CITY COUNCILLOR for RIVER HEIGHTS - FORT GARRY

March 6, 2013

Presentation to the Executive Policy Committee in regards to the selection of the route for the second leg of the South West Bus Rapid Transit Corridor.

**Parker Route**

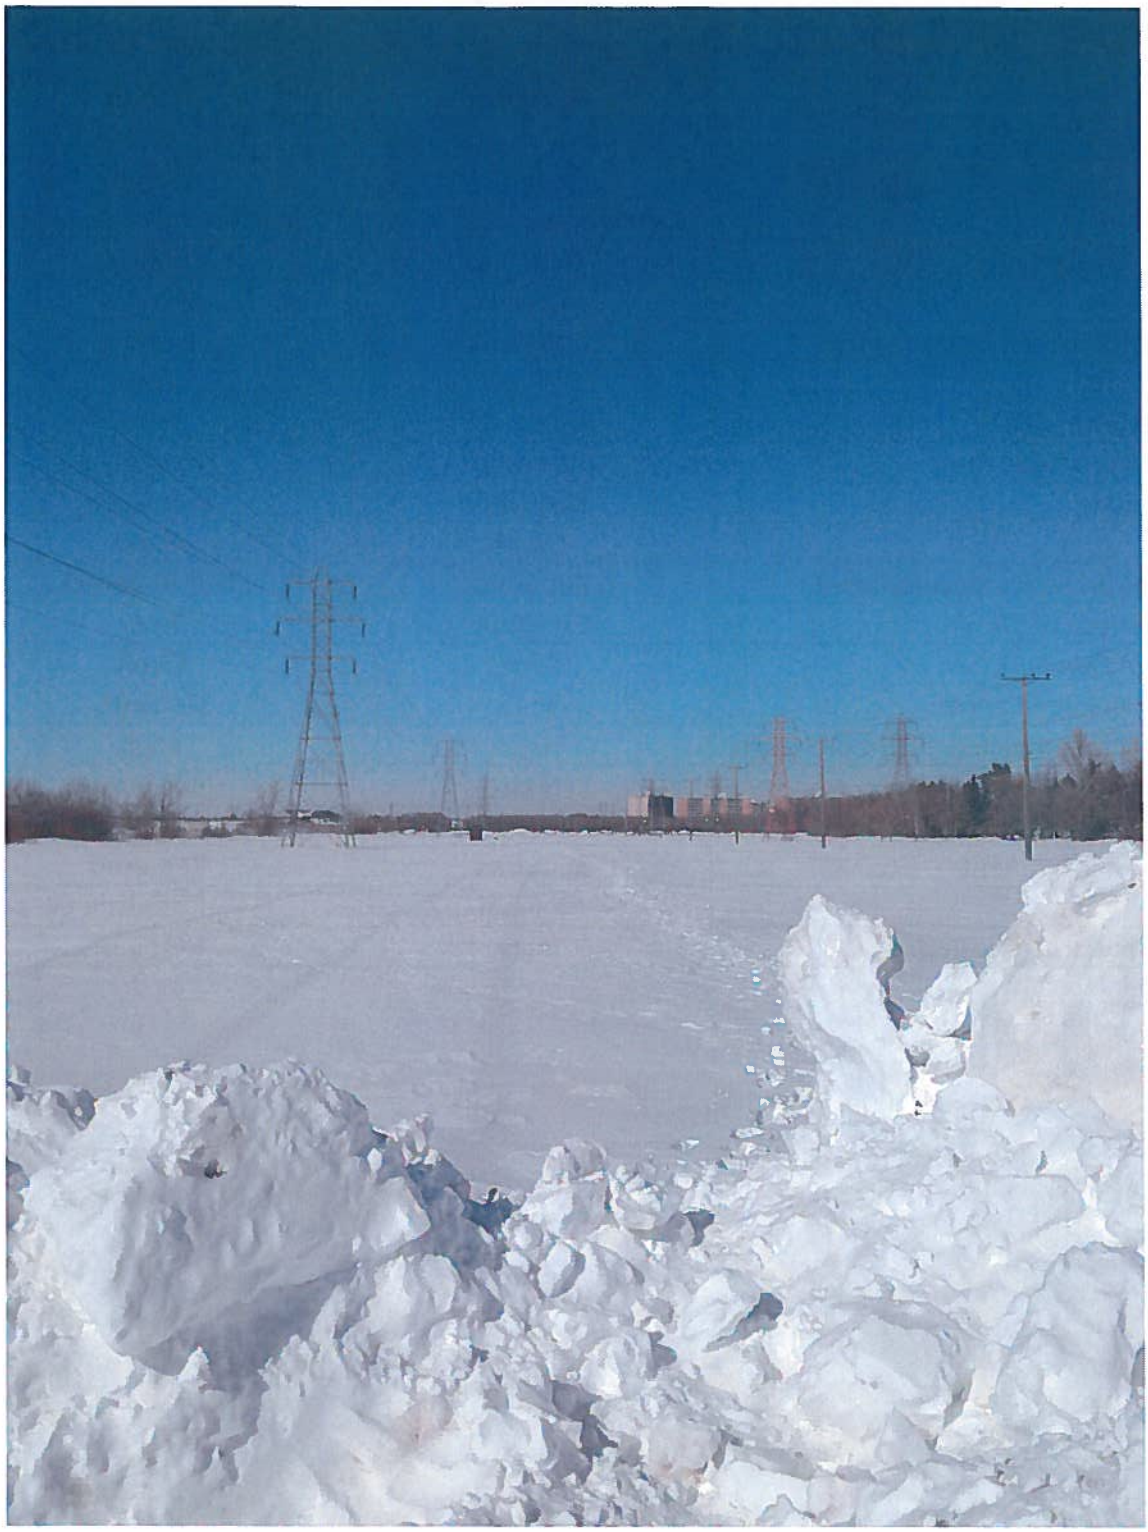
I also recommend that the EPC committee accept recommendation #3 that Figure 3 – Alignment 1B be modified to remove the possibility of an overpass at Beaumont St.

There was a question from the Committee in relation to my request for an amendment to the route map to remove the possibility of the Beaumont Over-pass from the Map.

I explained that by improving this access the existing issues associated with the street's use as a through fare, the addition of cars from the Parker Development, the increasing commuter traffic going from Waverley St. to Pembina Hwy. and BRT will use this improved access that will result in the neighborhood been cut in half.

Leaving the possibility of the over-pass on the Map that goes into the Transportation Master plan is too great a risk for the neighbourhood and asking for the neighbourhood to "trust" that it will not happen is not responsible. Recall this neighbourhood was not consulted when the Parker lands were traded for lands in Ft. Rouge. *(page 5 of the IRPW presentation)*
